# SERVICE INFORMATION LETTER

SERVICE INFORMATION LETTER NO. T-028

Revision 1

1. SUBJECT:            Landing Gear Fairing Assembly

**Figure 1. Landing Gear Fairing (Inboard View)**

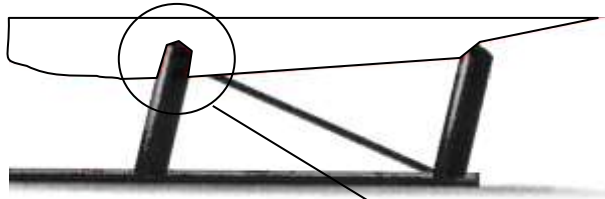
Enstrom has revised the landing gear fairing assembly to reduce labor hours for oleo fairing removal and re-installation. This method also eliminates the need of having to lift the aircraft for oleo fairing replacement.

This Service Information Letter (SIL) revises the landing gear fairing attachment hardware and provides information on incorporating this modification.

Revision 1 updates the Tinnerman nut to the correct part number.

- 5.1.1. Reference Figure 1 for location of applicable hardware.
- 5.1.2. Remove existing rivet. The rivet may be drilled out with the fairing installed.
- 5.1.3. Break tape seal with a slim instrument such as a putty knife and remove fairing from the landing gear.
- 5.1.4. Install P/N A06195-8Z-1D tinnerman nut with two (2) P/N CCR-264SS-3-2 rivets.
- 5.1.5. Remove existing double-back tape and use general purpose adhesive remover (3M 08984), or similar product, to remove adhesive residue. Wipe clean and allow to dry. Reapply new strip of double back tape along the full length of the fairing.
- 5.1.6. Reinstall fairing on landing gear.
- 5.1.7. Fasten fairing with P/N PK 8 x 3/8 screw.
